Final Drainage Report – Filing No. 1

Waterview East Commercial El Paso County, Colorado

Project #: 196195001

Prepared: March 12, 2026

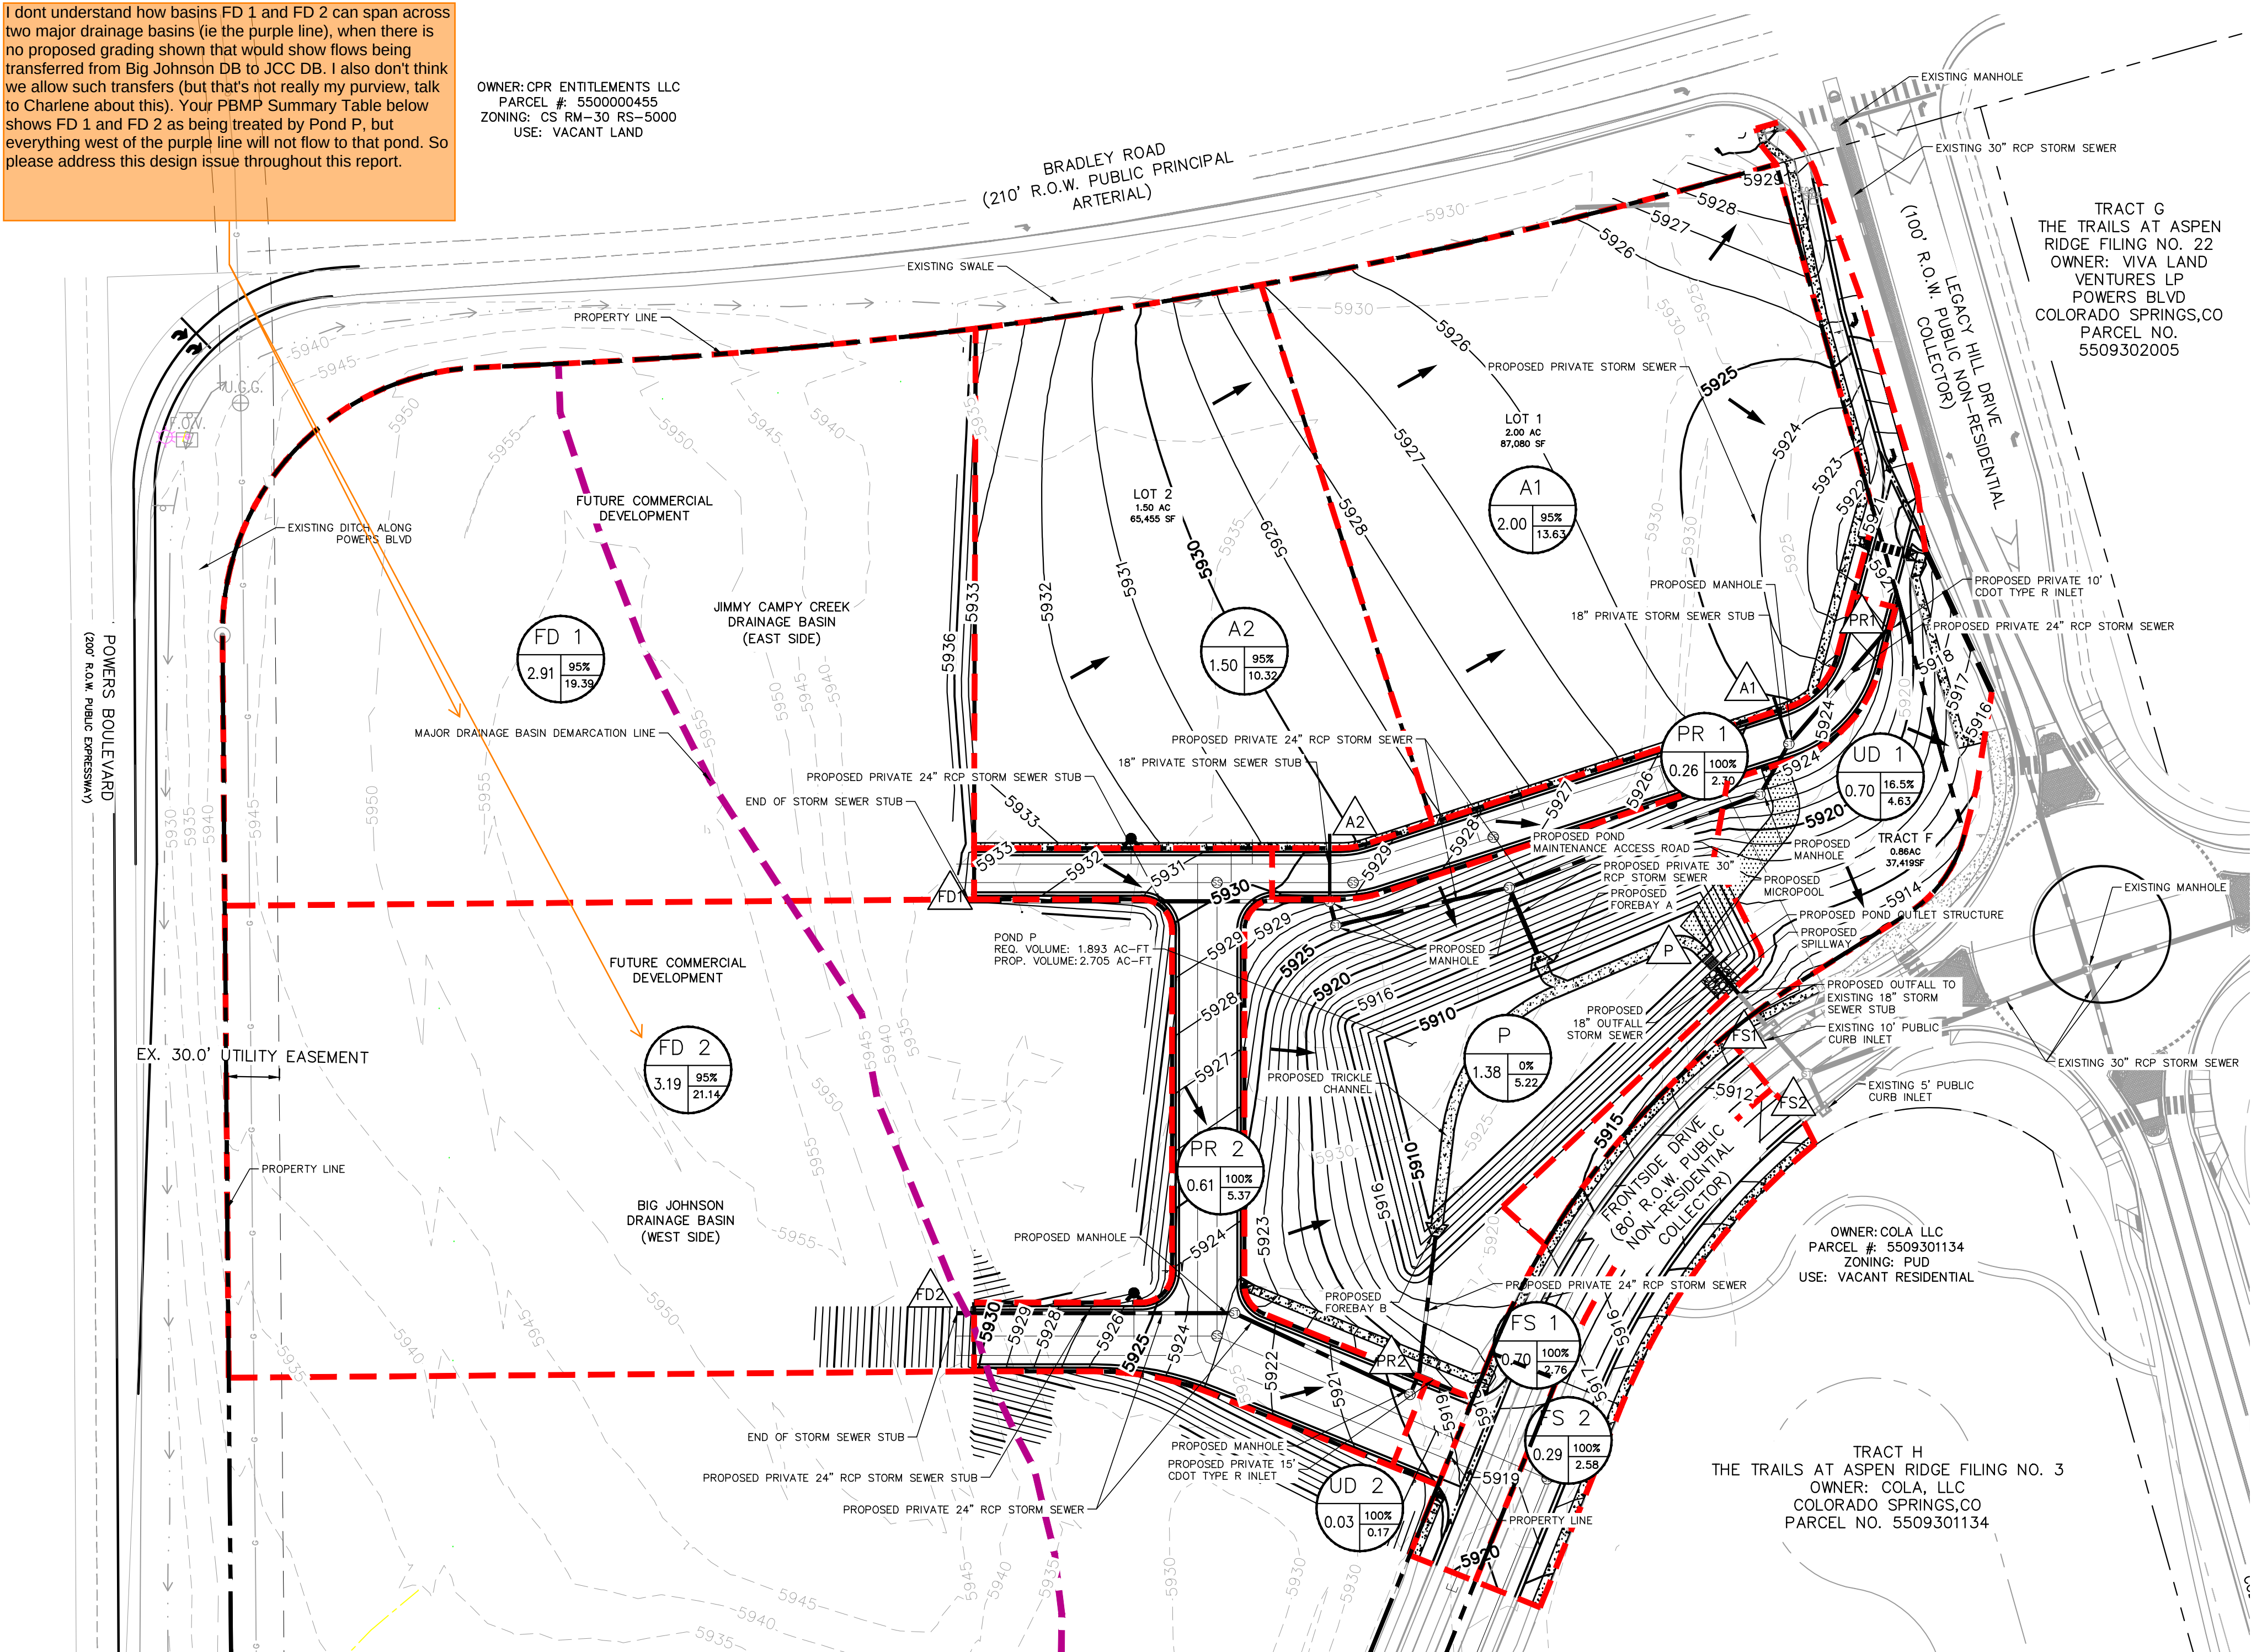
I dont understand how basins FD 1 and FD 2 can span across two major drainage basins (ie the purple line), when there is no proposed grading shown that would show flows being transferred from Big Johnson DB to JCC DB. I also dont think we allow such transfers (but that's not really my purview, talk to Charlene about this). Your PBMP Summary Table below shows FD 1 and FD 2 as being treated by Pond P, but everything west of the purple line will not flow to that pond. So please address this design issue throughout this report.

Is this only for Filing 1? Please clarify.

KH Response: FD 1 and FD 2 have been updated to not cross between the major drainage basins. Report and calcs have also been updated.

KH Response: Basin names in the table have been updated to match what is shown on the maps, reports, and calcs.

KH Response: This row was included by error and has been removed.

KH Response: This FDR is only applicable to Filing 1. Updated drainage exhibit title to reflect this.

KH Response: Boundaries between filings have been added with labels on either side stating Filing 1 on the east side and Future Filing on the west side.
